UNITED STATES PATENT AND TRADEMARK OFFICE

APPLICATION NO.	FILING DATE	FIRST NAMED INVENTOR	ATTORNEY DOCKET NO.	CONFIRMATION NO.
10/686,191	10/15/2003	David L. Hagen	P/3474-86	3800
2352 7590 07/10/2009 OSTROLENK FABER GERB & SOFFEN 1180 AVENUE OF THE AMERICAS NEW YORK, NY 100368403				
EXAMINER SOOHOO, TONY GLEN				
ART UNIT 1797		PAPER NUMBER		
MAIL DATE 07/10/2009		DELIVERY MODE PAPER

Office Action Summary

DETAILED ACTION

FIG. 1

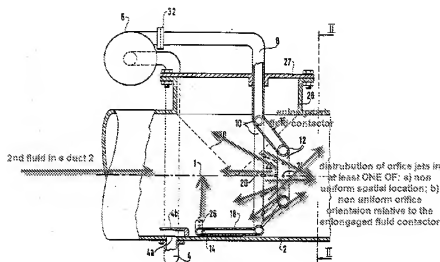
- (a) **non-uniform spatial location** (see location of 26 compared to 20, 22, fig 1)
- (b) non-uniform size
- (c) **non uniform orientation** (see arrows fig 2), relative to **one of the choice of:** 1) the axial, 2) radial and 3) circumferential directions of the elongated fluid contactor, excluding a 1st or 2nd orthogonal directions transverse to the mean streamwise flow;

A desired flow distribution of the 1st fluid is provided by a plurality of outlet orifices nozzles, which as seen in figures 1 and 2, by a non-uniform distribution of spatial location and orientation.

Note that the fluid contactor tube is formed from a conical, curved, thin walled tubular member extending transverse and along parallel in curvature into the flow path of the 2nd flow. There is also an elongation section 18 along the path of the pipe 2. Each of the elongation sections have a curvature radii along the length as seen in figs 1 and 2.

FIG. 2

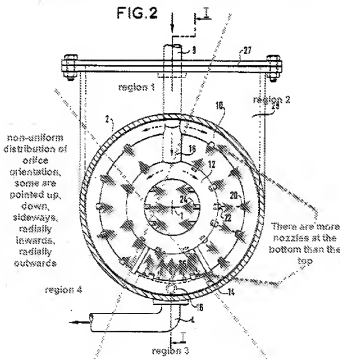
- e. a fluid delivery system
- f. a duct 2
- g. an elongated fluid contactor 8, 10, 12, 16, 18, 14
 - i. an inlet 32
 - ii. a plurality of outlet orifices 20, 22, 26 (fig 2) in the elongated fluid contactor

regions along the curvilinear path along the contactor surface having at least four differing regions along the curvilinear path along the "contractor" [sic] surface. (see markup figure with four exemplary regions)

24. However, it also shows at least four "regions" in the manner required by the claim as seen in the markup figure.
